STAFF ANALYSIS

Case No.:	CZ-22-1246090	Agenda #:	N10
Location/ Address:	Southwest side of Bermuda Road, approximately 658 feet northwest of Malvern Boulevard at 1347 Bermuda Road in Stone Mountain	Commission District:	4 Super District: 7
Parcel ID:	18 083 01 010		
Request:	A major modification to zoning conditions pursuant to CZ-20-1243972 to reduce the number of single-family detached lots from 19 to 6 lots.		
Property Owner:	Future Capital Investment c/o Kirk Harvey		
Applicant/Agent:	Future Capital Investment c/o Kirk Harvey		
Acreage:	6.6		
Existing Land Use:	Vacant Single-Family structure		
Surrounding Properties:	Single-family homes and a single-family subdivision (English Manor) to the north; vacant land and single-family homes to the east across Bermuda Road; a single-family subdivision to the south (Deer Creek); and single-family homes to the west.		
Adjacent Zoning:	North: R-100 South: RSM East: NA Gwinnett County West: R100

Staff Recommendation: FULL CYCLE DEFERRAL

Sheet No. 01
OF 03

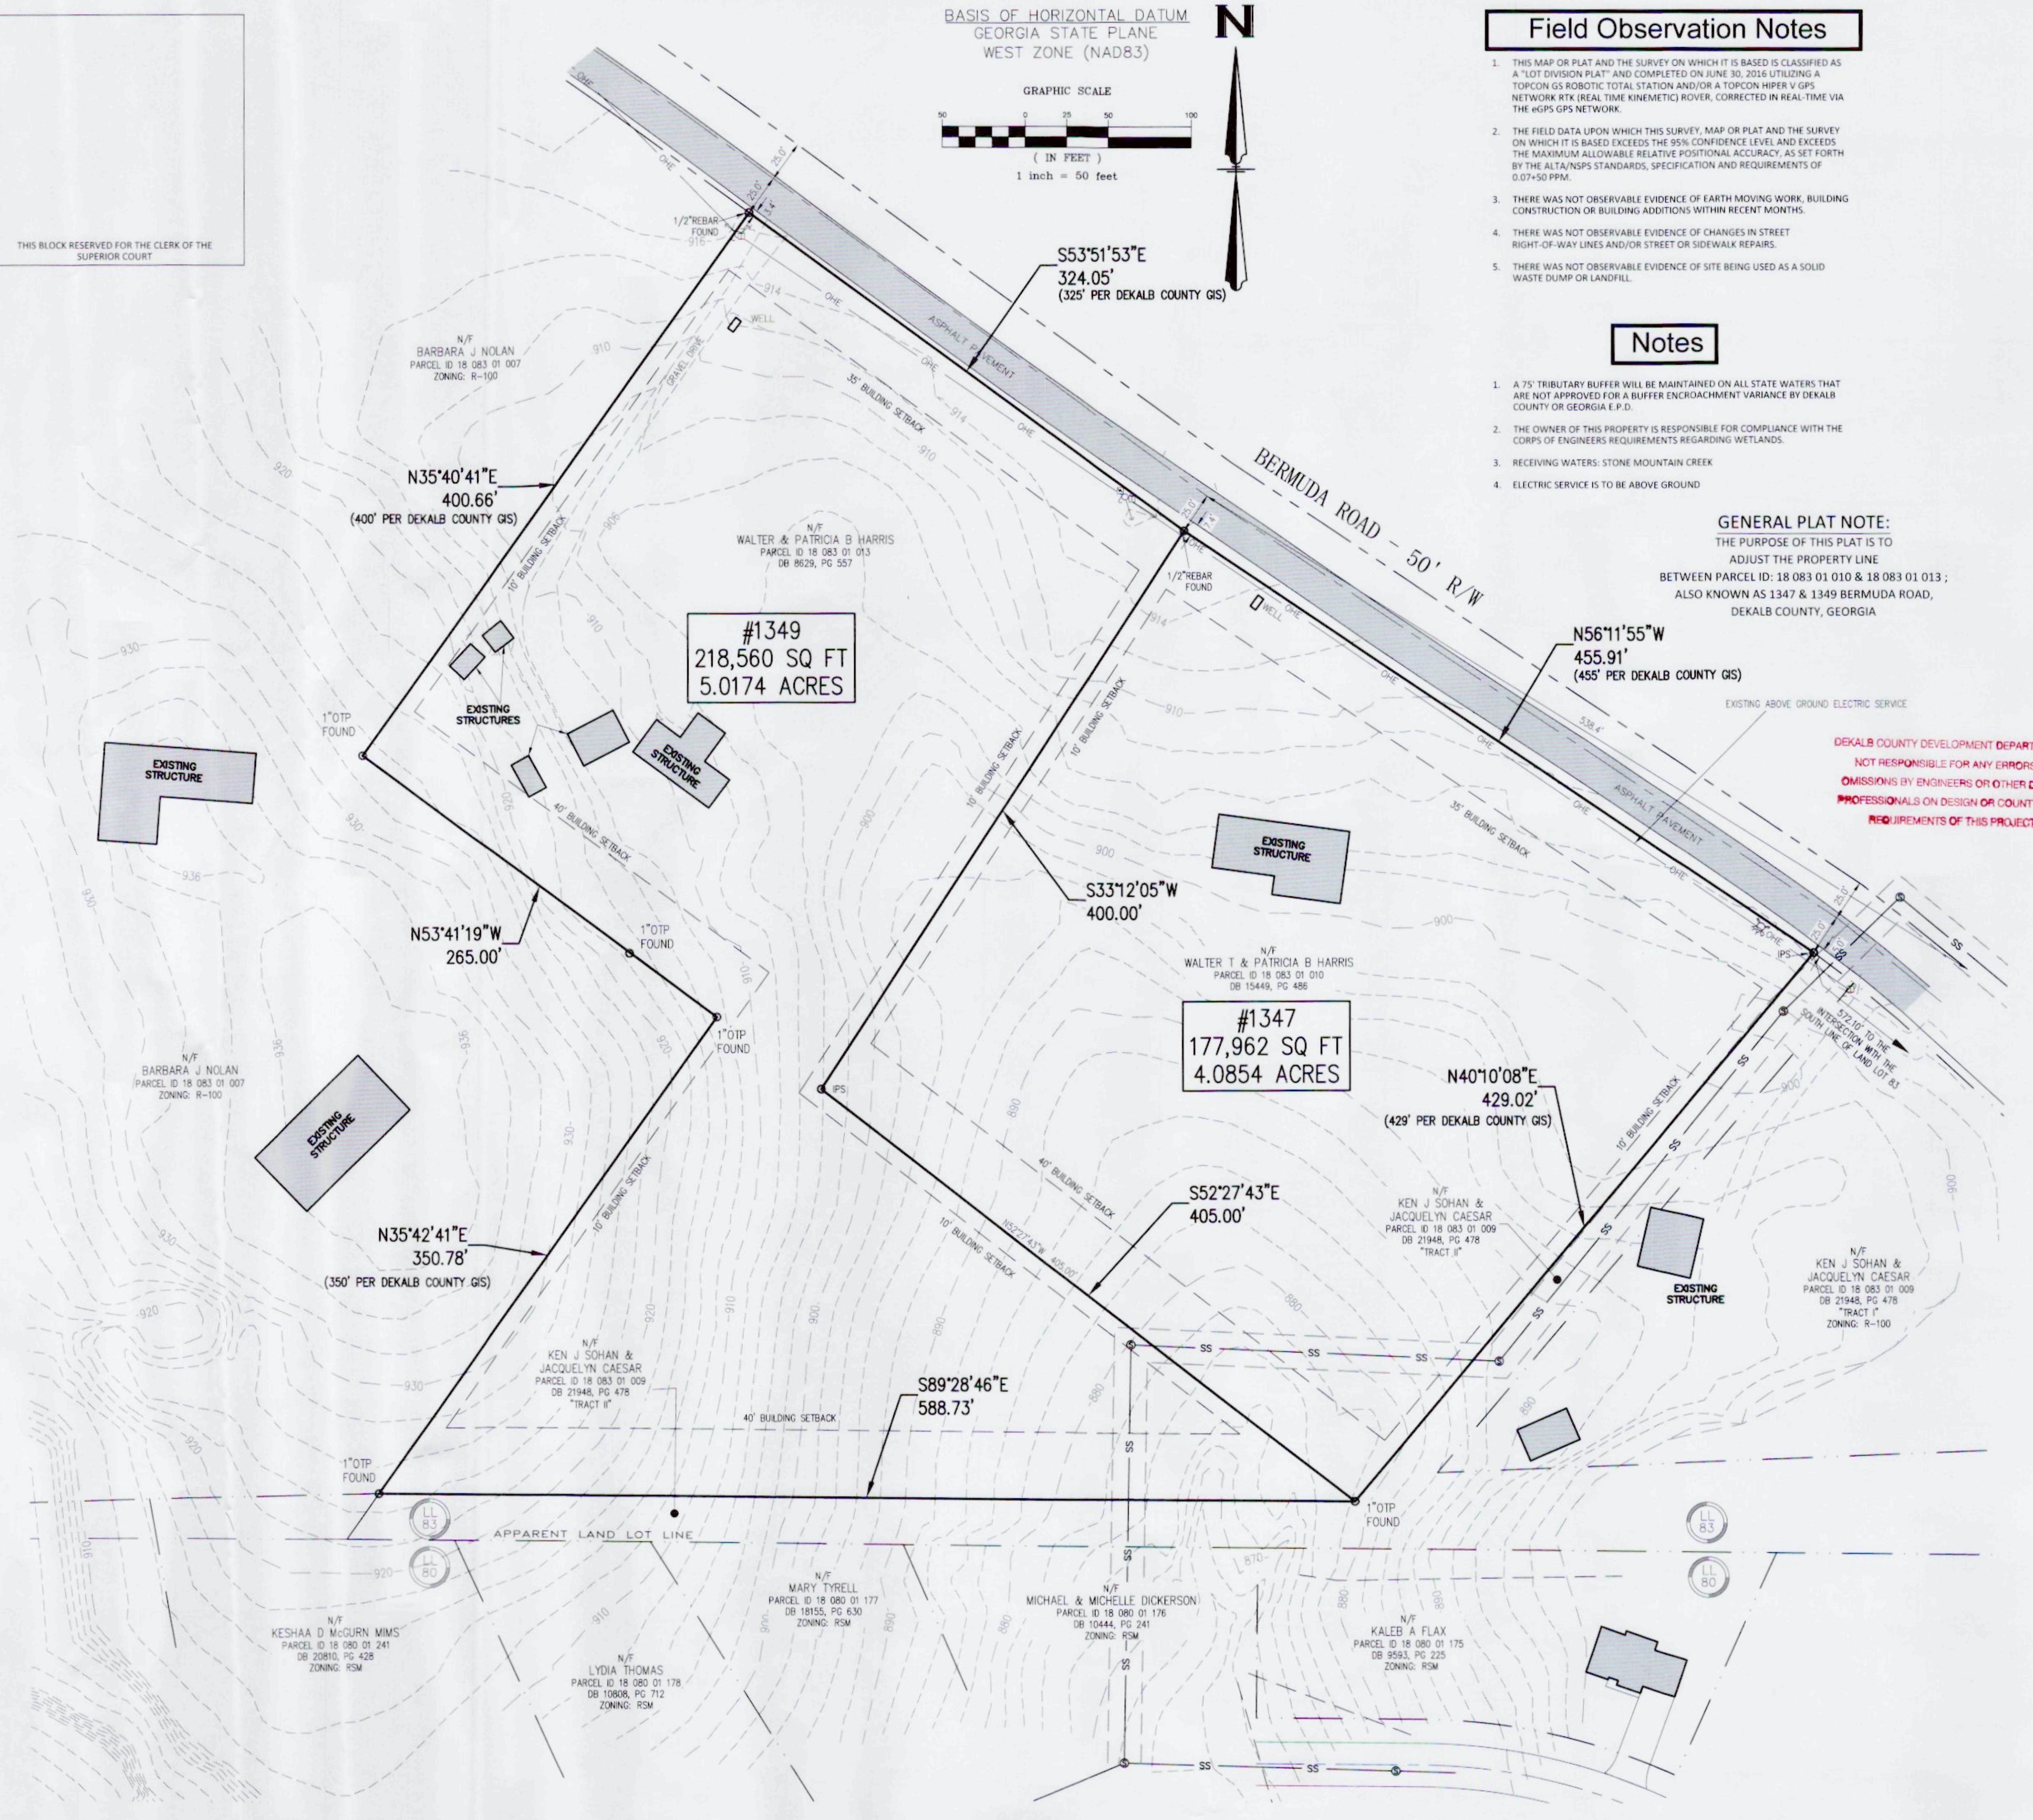
Conceptual plan doesn't indicate the location of the stormwater management facility. Location of stormwater management shall be shown or compliance with the County stormwater management regulations shall be explained.

N10. 1347 Bermuda Road. By Code- shared driveways can only be for 2 lots. A variance will be necessary to have 6 lots on a shared driveway. Suggestion: widen to 24 feet and make it a private road. Bermuda Road is classified as a collector road. requires a right of way dedication of 35 from centerline OR such that all public infrastructure is within right of way, whichever greater. Requires a 5 foot landscape strip with a 10 foot mulituse path. No poles may remain within the limits of the path. Requires pedestrian scale streetlights. Watch minimum separation of drives/roads in section 14-200(6) based on the speed limit of the road.

Possible Variances: Proposed shared drive will be reviewed to verify compliance with Transportation Department and Zoning Ordinance requirements. From a conceptual standpoint Planning Department would prefer the access drive to provide access to the rear of the proposed lots. Show compliance with RSM requirements including but not limited to minimum lot area and lot width, required parking, parking lot landscaping, minimum open space, maximum building height, transitional buffers, streetscape improvements (sidewalks/street trees/street lighting), building materials, outdoor lighting, etc. The applicant is encouraged to discuss possible transportation improvements that may be required (if the rezoning is approved by the Board of Commissioners) with the county Transportation Department. The applicant is encouraged to contact Land Development Division of Public Works regarding required storm water management, floodplain, and stream

Sheet No. 02
 OF 03

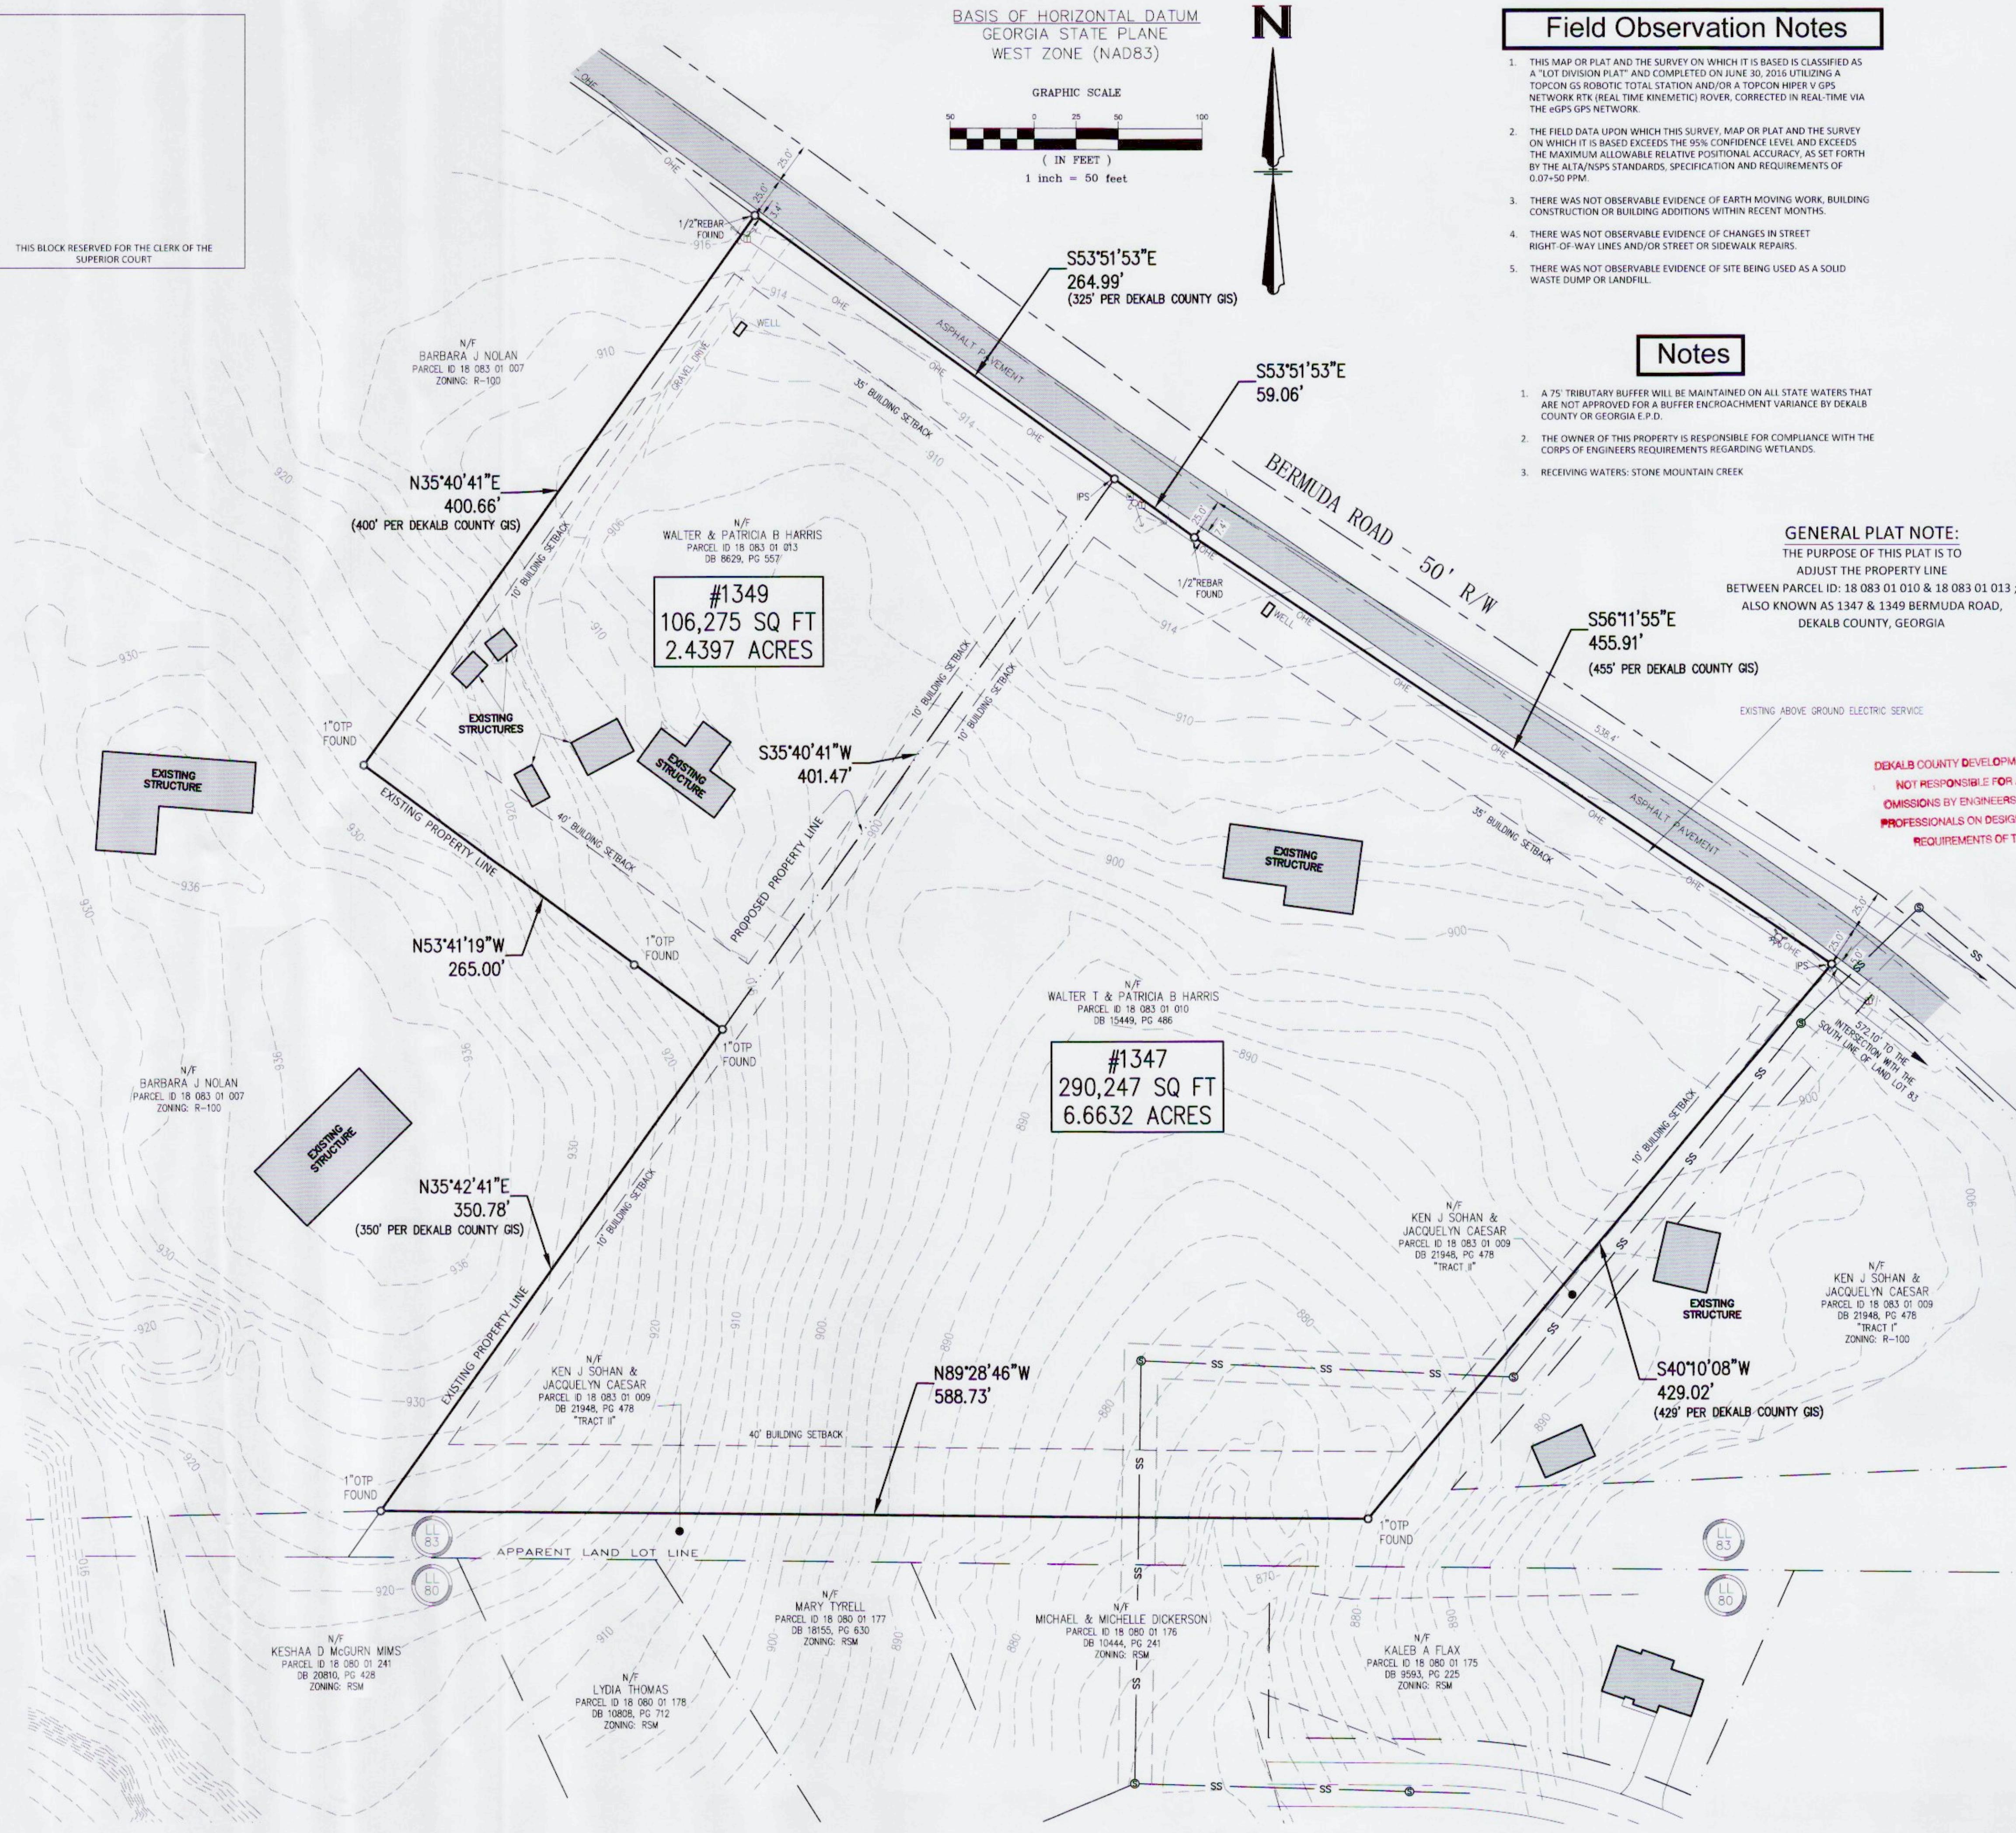
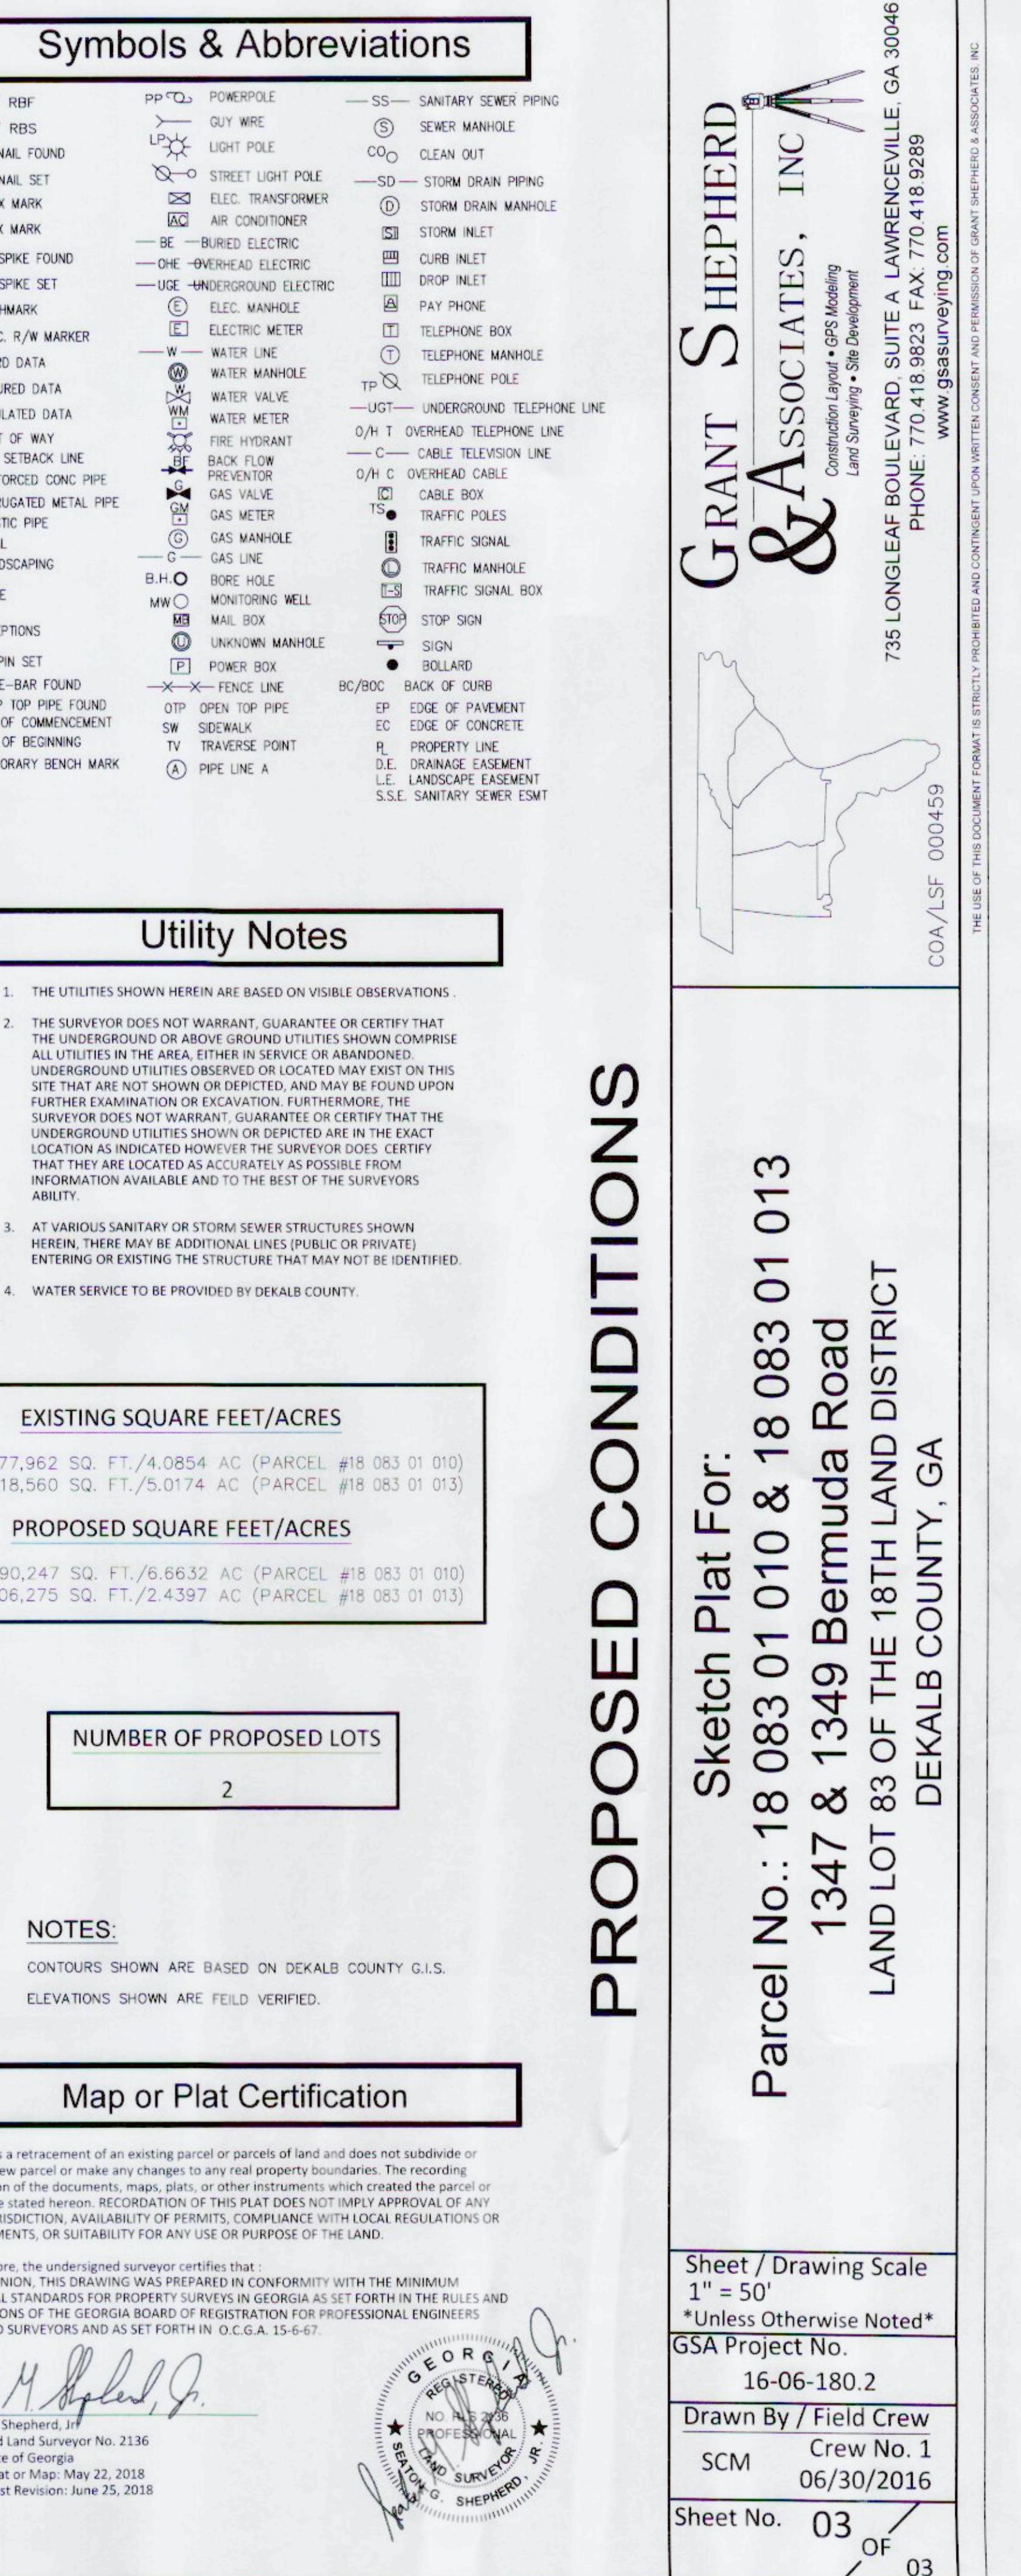
Notwithstanding these positive site plan features, the revised plan proposes a different access and building orientation scenario than what was originally approved. The previously approved plan provided access to all the homes via a new public street with all units facing the interior of the project site, while the proposed plan provides access via a shared access driveway with all units fronting along and facing Bermuda Road (see attached). The Planning Department would prefer that the shared access driveway be relocated behind the proposed homes so that the garages would not be visible to the motoring public along Bermuda Road. The applicant has indicated that while that design scenario would be ideal, the steep topography of the site would prevent that from being implemented. However, the applicant indicates that the project will comply with the Bermuda Road landscaping condition that was previously adopted with the original RSM zoning approval (see Condition #15) which should hide the proposed garages from view as much as possible. The Zoning Board of Appeals (ZBA) will be required to review the proposed shared driveway on its merits since Sec. 5.7.5.F.2 of the Zoning Ordinance allows a maximum of two lots to share the same driveway and the plan shows shared driveway access to six lots.

More information is needed to verify compliance with stormwater management regulations. The Land Development Division indicates that the conceptual plan doesn't indicate the location of the stormwater management facility. The Land Development Division strongly recommends that a design professional investigate the site and identify location where runoff Run-off Reduction Volume (RRV) can be provided and re-design/revise the layout to comply with the RRV requirement (see attached interdepartmental comments from Land Development Division).

Therefore, it is the recommendation of the Planning & Sustainability Department that the request be "*Deferred Full Cycle*" to allow the applicant time to address the stormwater management regulations and re-design or revise the plan as needed to comply. Should the Board decide to approve the request, Planning Staff recommends the following conditions (additions from the previously approved zoning conditions are in **blue bold**, and proposed deletions are in **red strikethrough**).
